**Re: Independence Road Reconstruction Phase 4**

**CONTRACT ADDENDUM #1**

# INDEPENDENCE ROAD PHASE 4 STP-7302 (659)

ADDENDUM 1  
EXHIBIT A - OS 107

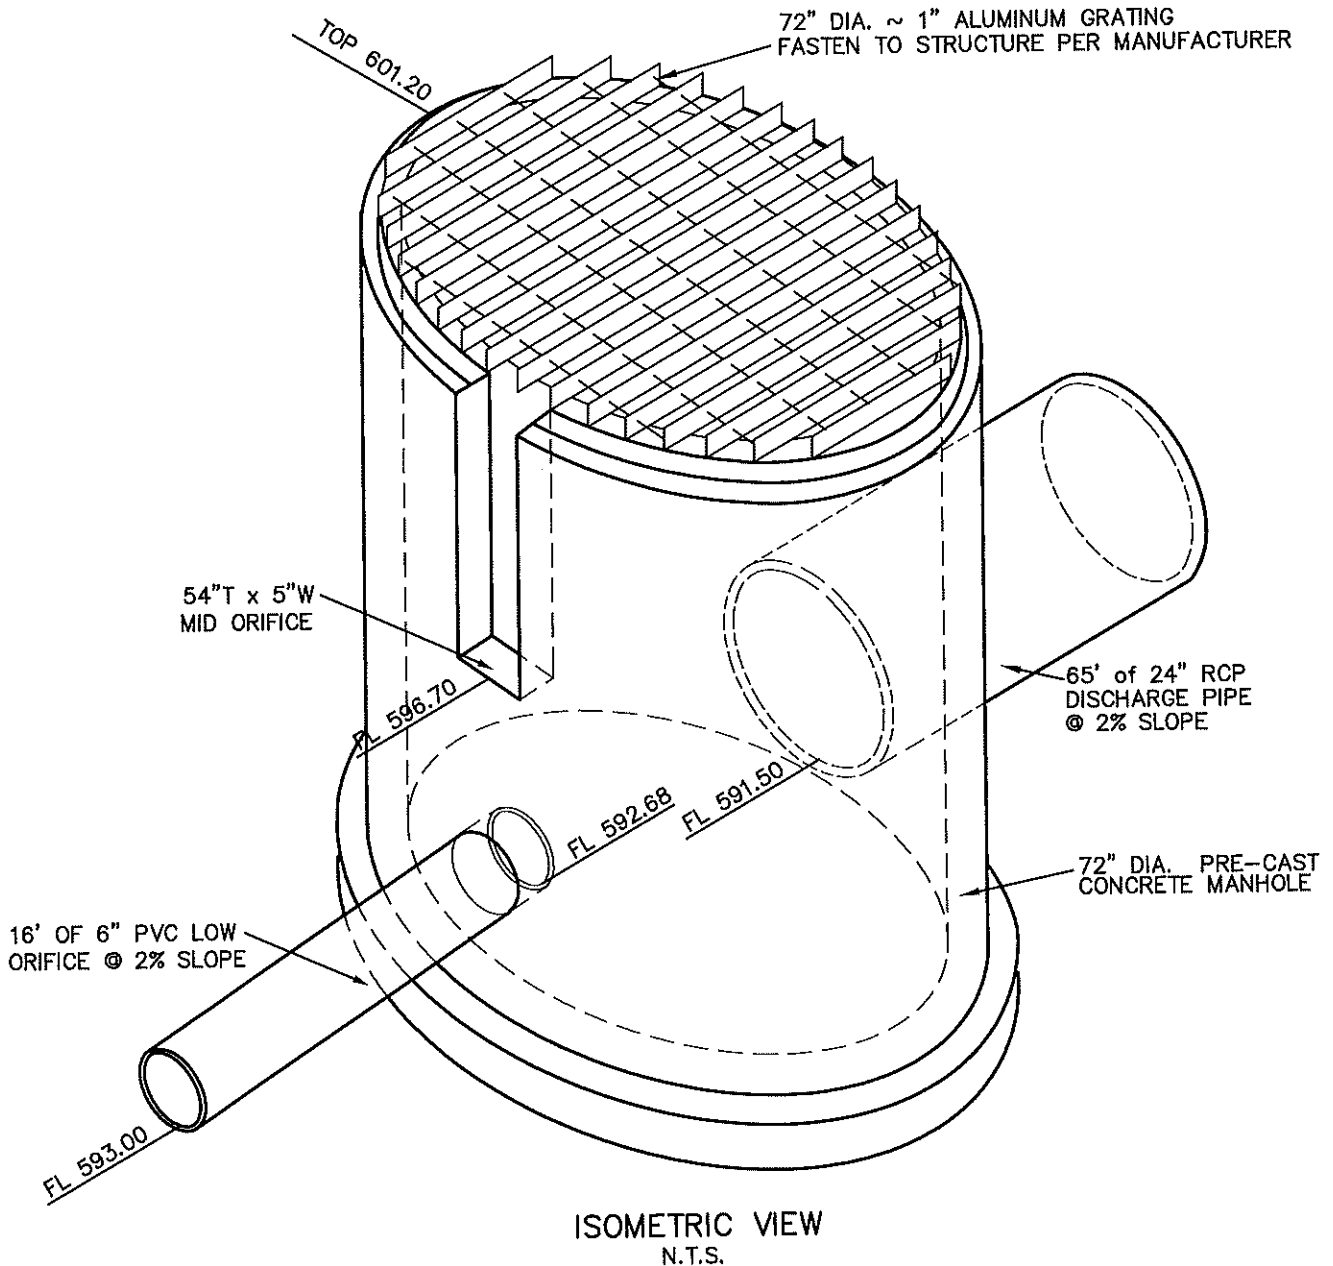
- 7) A detail for outfall structure OS-107 is attached with a bid item for the outfall structure added to the BID FORM.

TITLE: LPG-10  
 10" PIPE GUARD GRATE

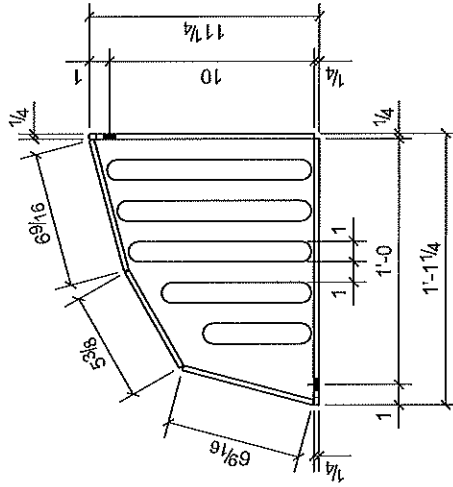
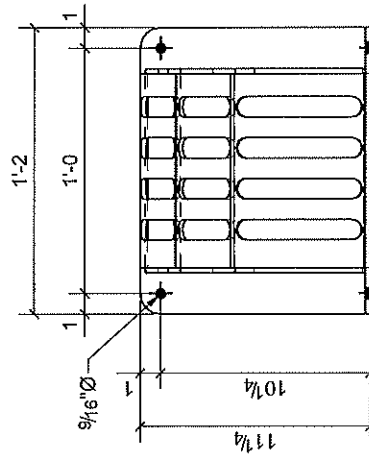
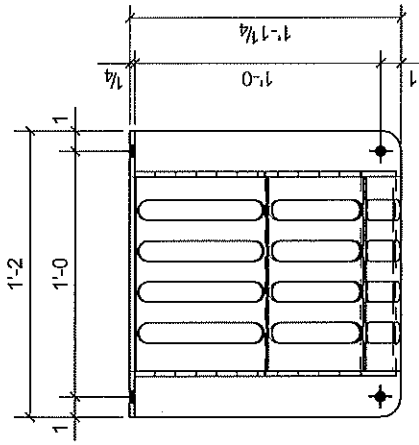
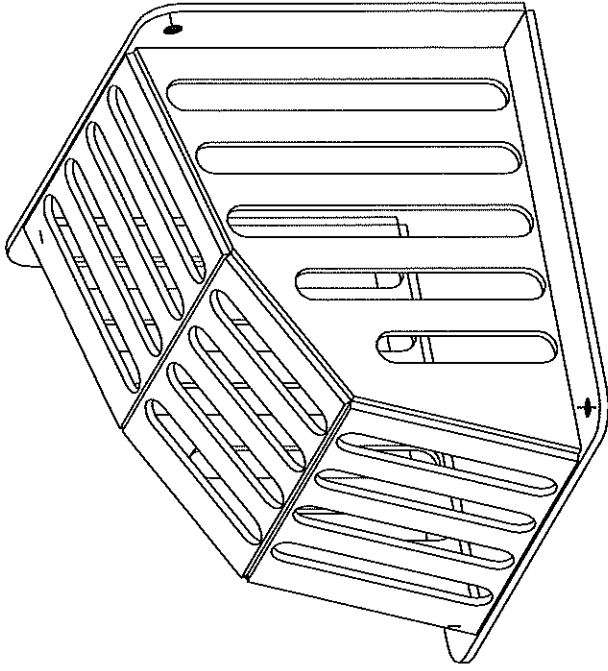
- 8) A detail of the OS-107A trash rack is attached and a bid item is added to the BID FORM for the 6 inch pipe, the concrete pad, and the trash rack.
- 9) A bid item was added for permanent seeding as determined necessary by the City in locations that are not residential lots.
